TI_2603: Quality defect steam generator water inlet safety fitting

iCombi Pro / iCombi Classic

07/09/2026

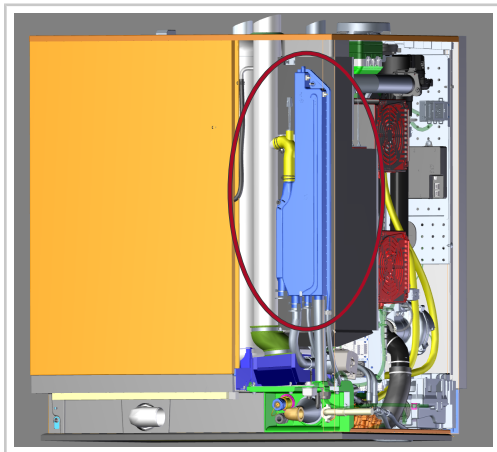
We would like to inform you that we have received isolated reports of leaks on the steam generator water inlet safety fitting (hereinafter referred to as the Combi water box). The cause is a cracked weld seam on the Combi water box. The cracked weld seam can only occur after transport from Landsberg.

RATIONAL has already identified the cause of the error. The affected period cannot be completely narrowed down. Therefore, install all units with the split rear panel open and check the Combi water box for leaks.

To avoid unnecessary breakdowns, bring the spare part for the Combi water box with you during installation. If necessary, replace the Combi water box immediately.

Component	Item number
Safety fitting water inlet steam generator	87.01.548S
